TRANS/WP.29/GRSG/2003/22
24 July 2003

PROPOSAL FOR DRAFT AMENDMENTS TO THE DRAFT 02 SERIES OF AMENDMENTS
TO REGULATION No. 107

(M2 and M3 vehicles)

Transmitted by the expert from the International Organization
of Motor Vehicle Manufacturers (OICA)

"Figure 1

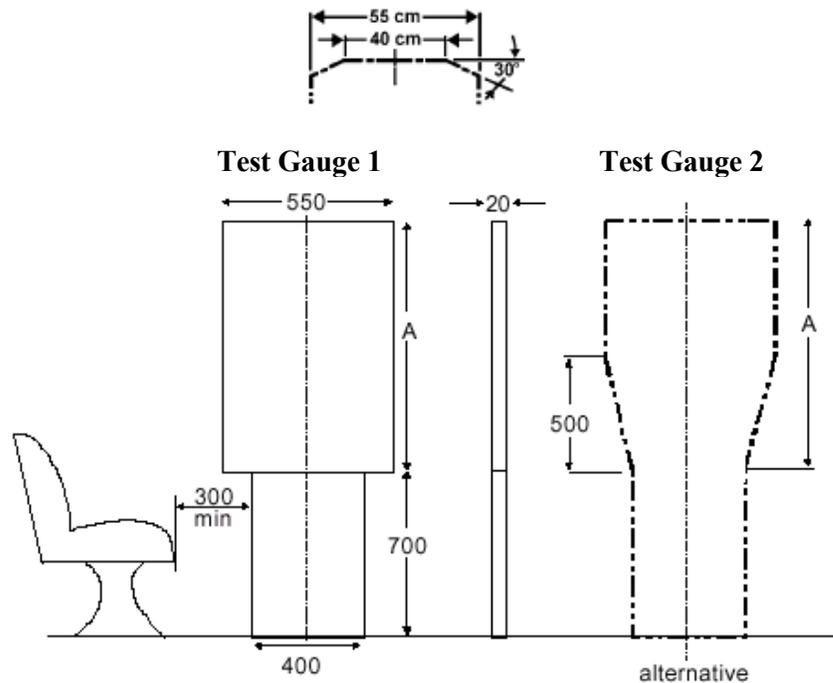
Annex 4, figure 1, amend to read:

Note: Both test gauge diagrams should be revised before publication to incorporate the revised top as shown below, amended to refer to "550mm" and "400mm" as appropriate. Replace "alternative" below gauge 2 with 400mm dimension as gauge 1.

Vehicle Class	Height of the upper panel (mm) (Dimension 'A' figure 1)		Total height
	Test gauge 1	Test gauge 2	
Class A	950 (*)	950	1650
Class B	700 (*)	950	1400
Class I	1100	1100	1800
Class II	950	1100	1650
Class III	850	1100	1550

(*) For vehicles having a capacity not exceeding 22 passengers, the lower panel may be displaced relative to the upper panel provided that it is in the same direction."

Re. paragraphs 7.7.1.1., 7.7.1.2. and annex 4, Figure 1:

Clarification and correction – No change of substance.
